## Product Change Notice (PCN)

**PCN Number:** PCN-0451156R-01

**Product(s) Affected:** PJ-039A, PJ-039B, PJ-039AH, PJ-039BH

Current version	New version
Outlook		
Front	<p>without chamfer</p> 	<p>with chamfer</p>

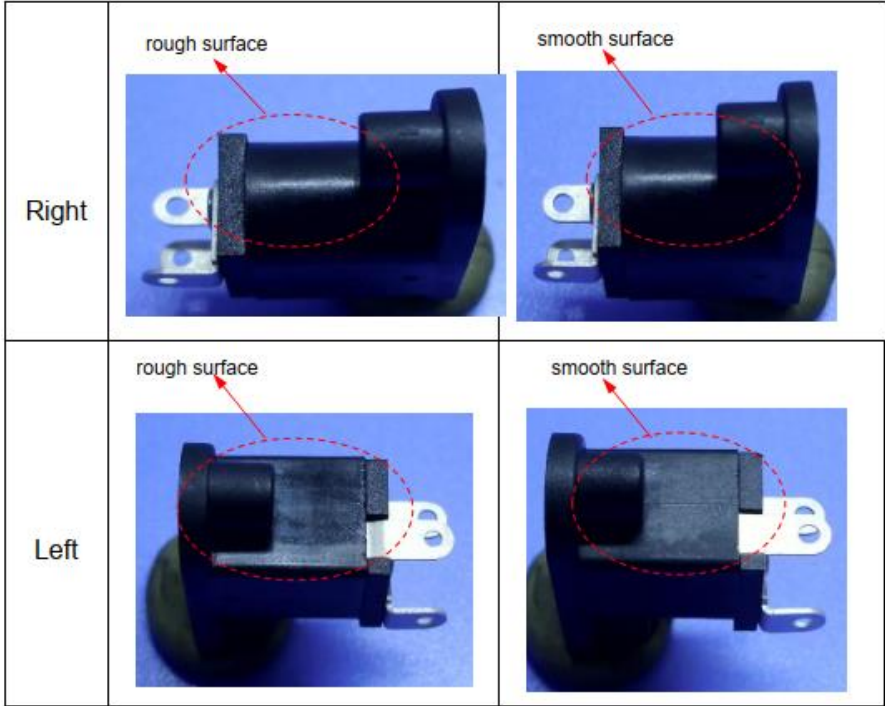
**Description of Change:** Thickness of pin 2 changed from 0.2mm to 0.25mm. Aesthetic changes as shown in below comparisons:

Back	<p>cave marking location</p>  <p>smaller</p> <p>cave marking location</p>	<p>cave marking location</p>  <p>thicker</p> <p>cave marking location</p>
Top	<p>with injection mark</p>  <p>thickness of pin#2 is 0.2mm</p>	<p>without injection mark</p>  <p>thickness of pin#2 is 0.25mm</p>
Bottom	<p>without injection mark</p> 	<p>with injection mark</p>
